SPIRE-RAL-NOT-001940

QM DRCU INTEGRATION

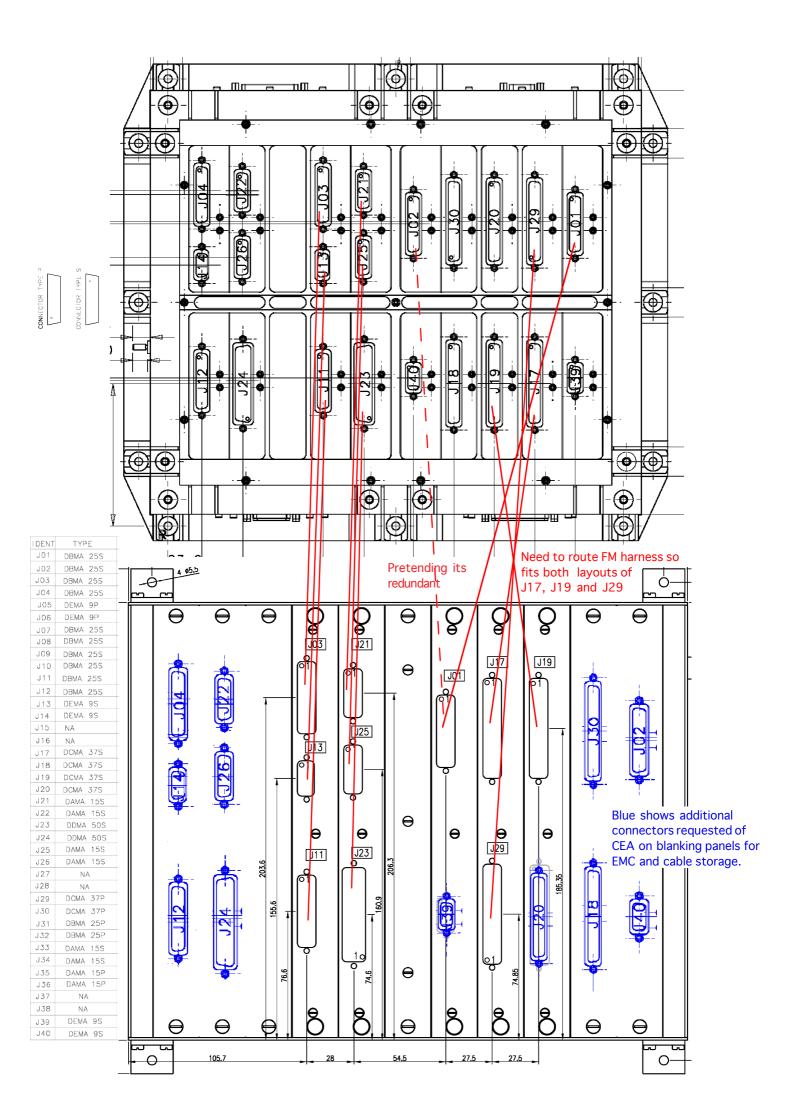
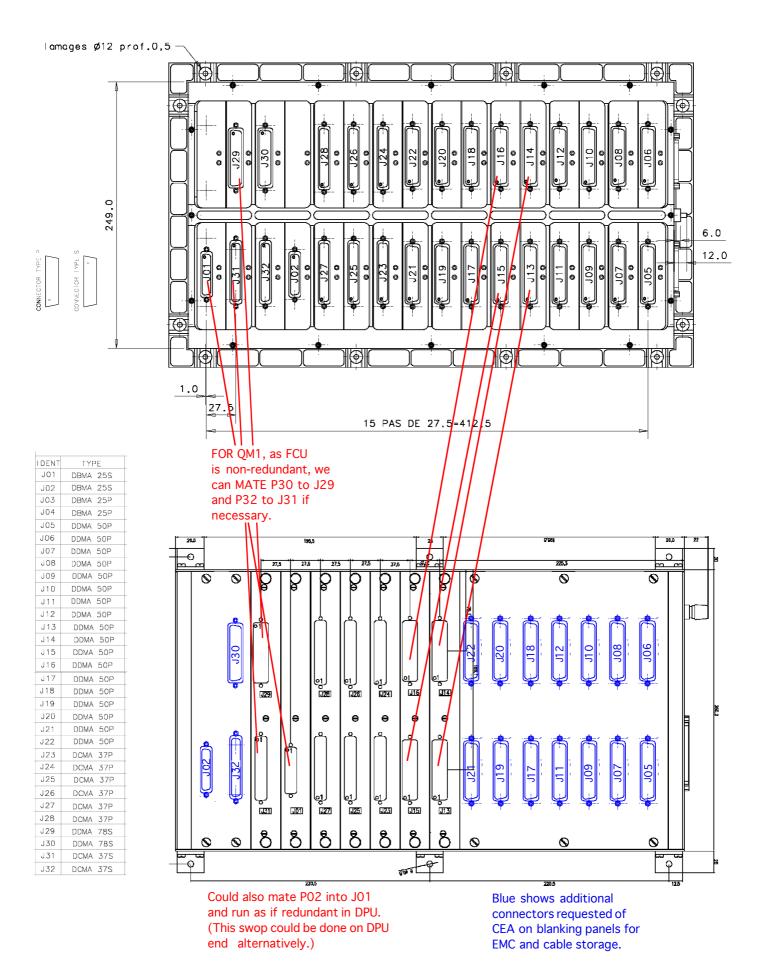
Let this bend cut corner and with lower height of unit check that J17 and J19 will reach across to QM posn.

CONCLUSION: AS FAR AS THE DCU IS CONCERNED, THE QM1 CAN USE THE SAME CABLES AS THE FM, PROVIDED SLIGHT SIDEWAYS SHIFT ON LINKS 13-16 is OK.
